Re: Zoning Application - Stormwater Treatment Design for 3-Acre Permitting  
Riverview Commons  
Richmond, VT

# SITE PLAN APPLICATION

**Subject:** Re: Riverview Commons 3-Acre Stormwater Treatment Project

STORMWATER  
 TREATMENT DESIGN  
 FOR 3-ACRE PERMIT

SHEET NUMBER  
**11**  
SHEET 11 OF 13

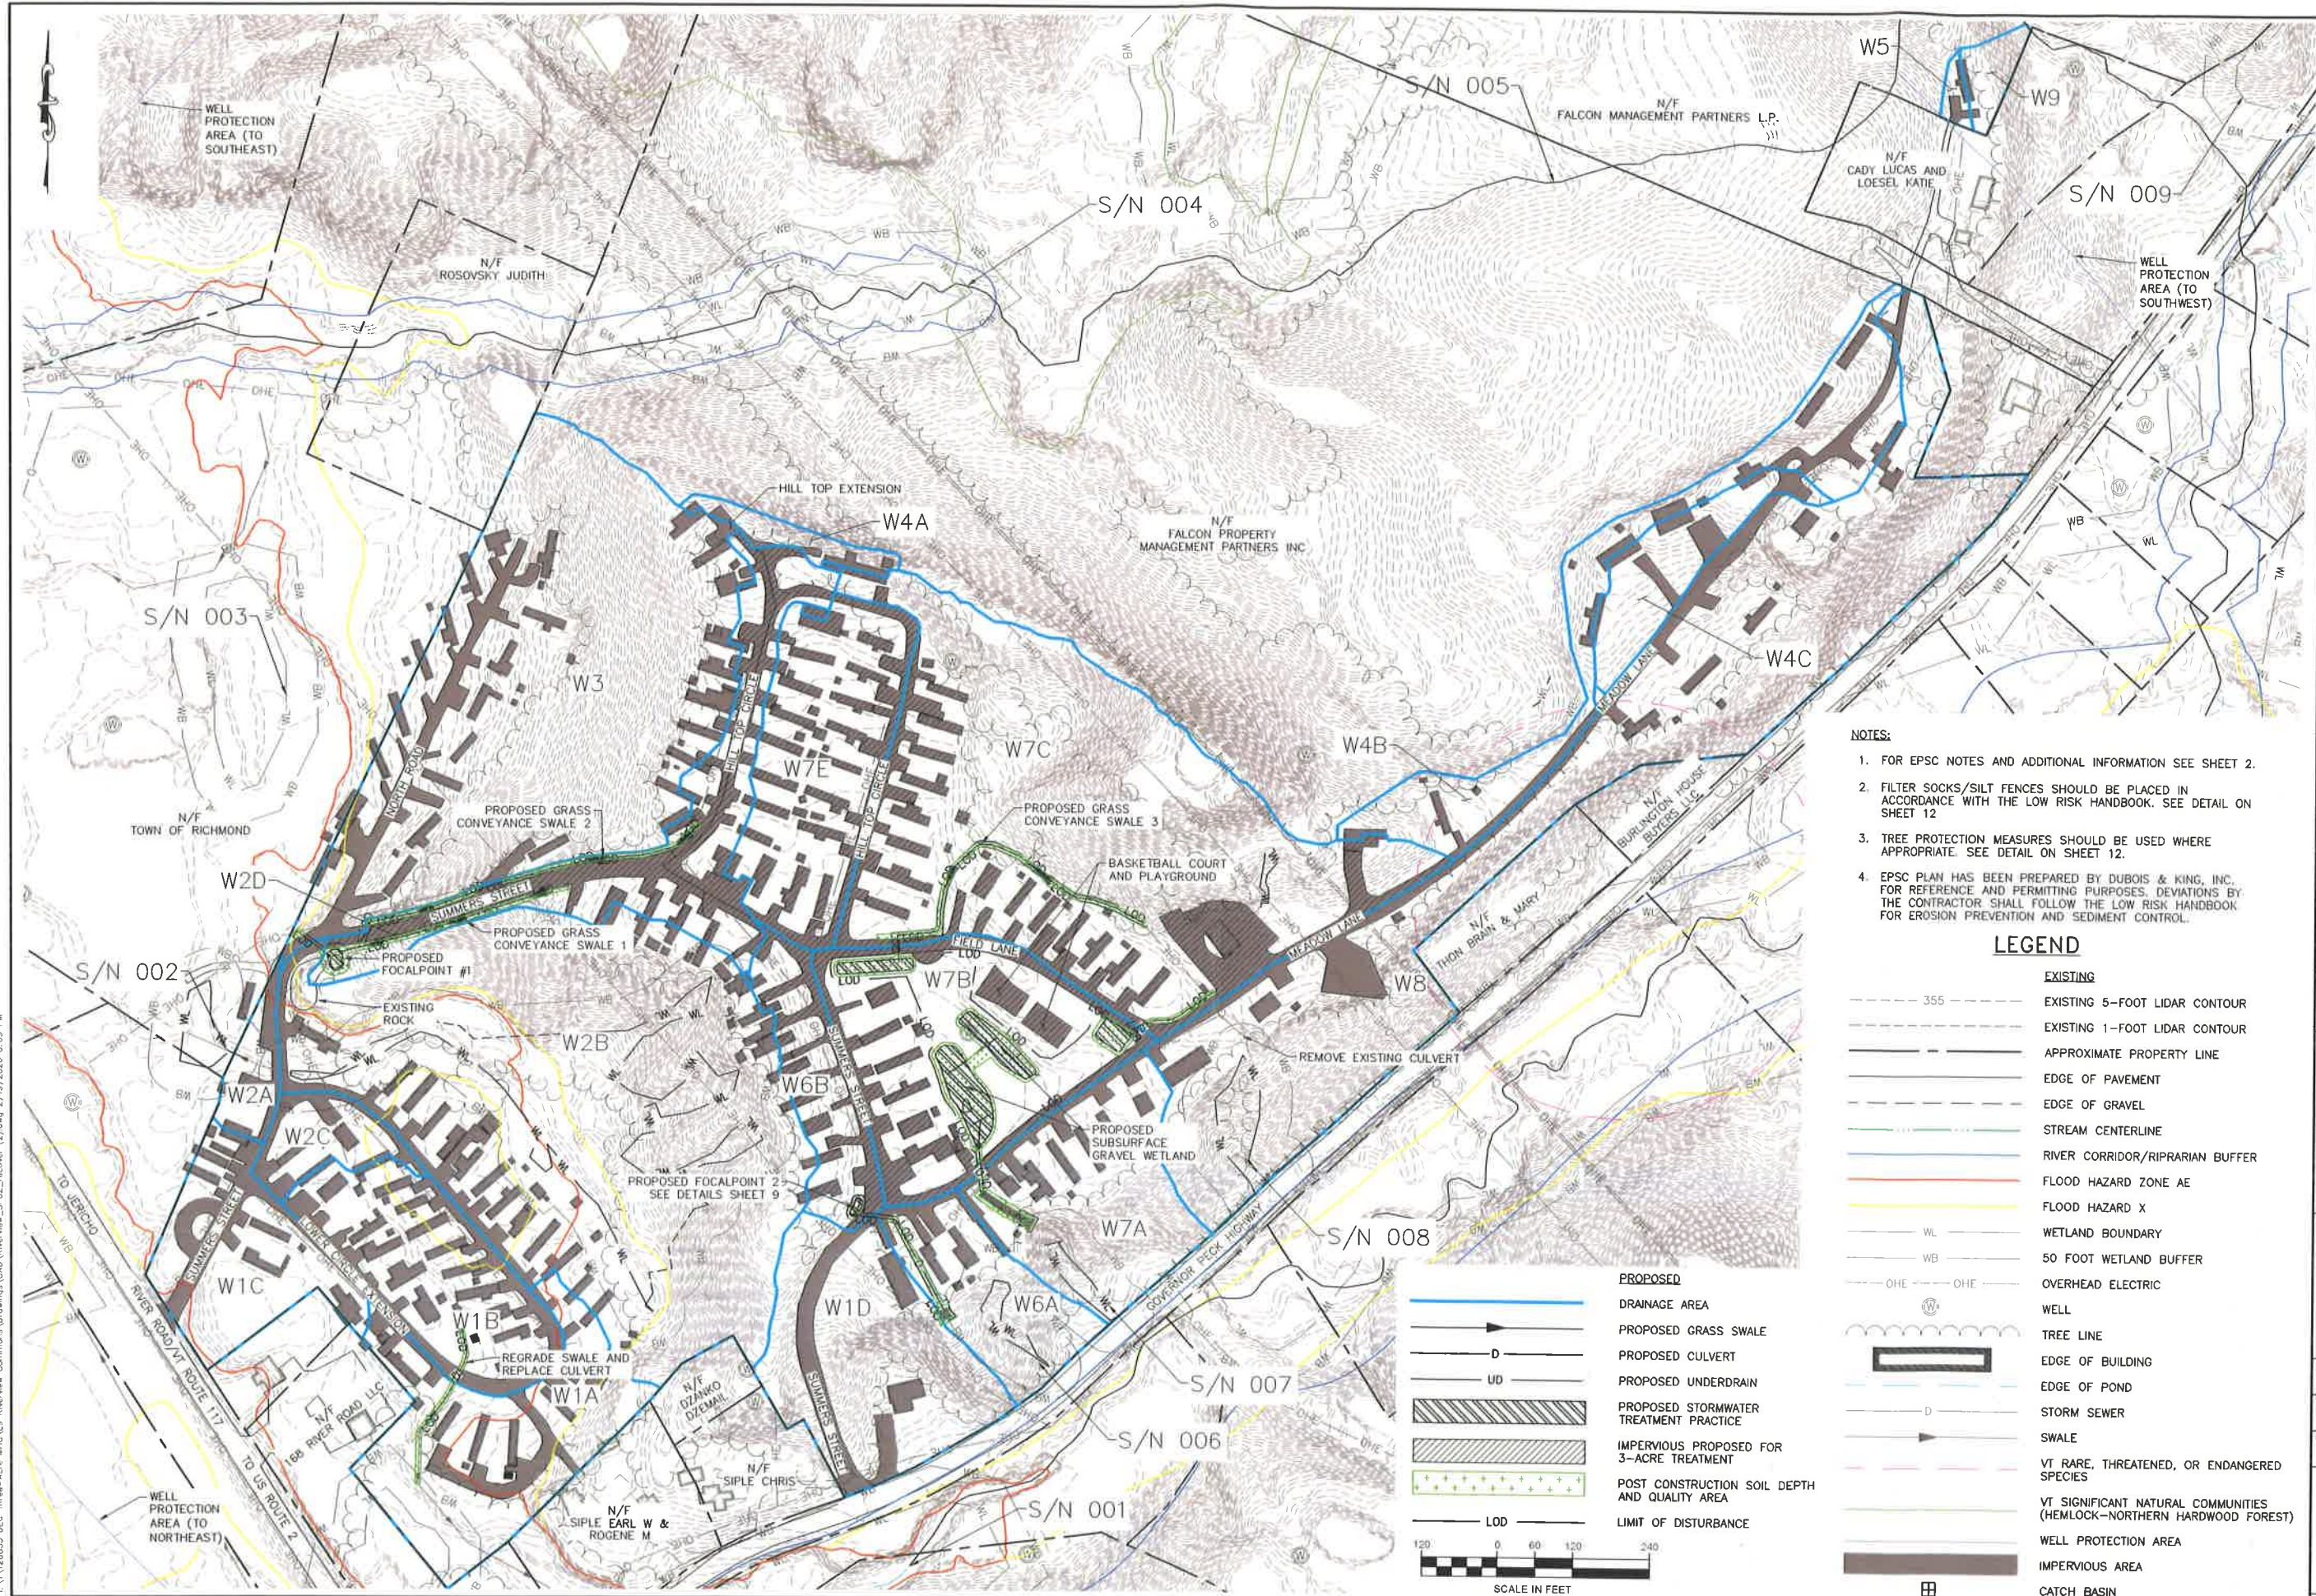
Upon review of Sheet 11, we noticed proposed plans to "regrade swale and replace culvert" located in the Flood Hazard Overlay District (FHOD) on Lower Circle Extension. All other proposed plans seemingly fall outside of the FHOD. Because insignificant repairs (those worth less than \$500) and maintenance (of storm water drainage areas, culverts, or channel management activities) are exempt activities under RZR Section 6.8.10 and no other proposed work falls within the FHOD, effectively, all proposed development falls outside the jurisdiction of the FHOD or is otherwise exempt from FHOD review. Thus, the FHOD regulations do not seemingly apply to this project as proposed.
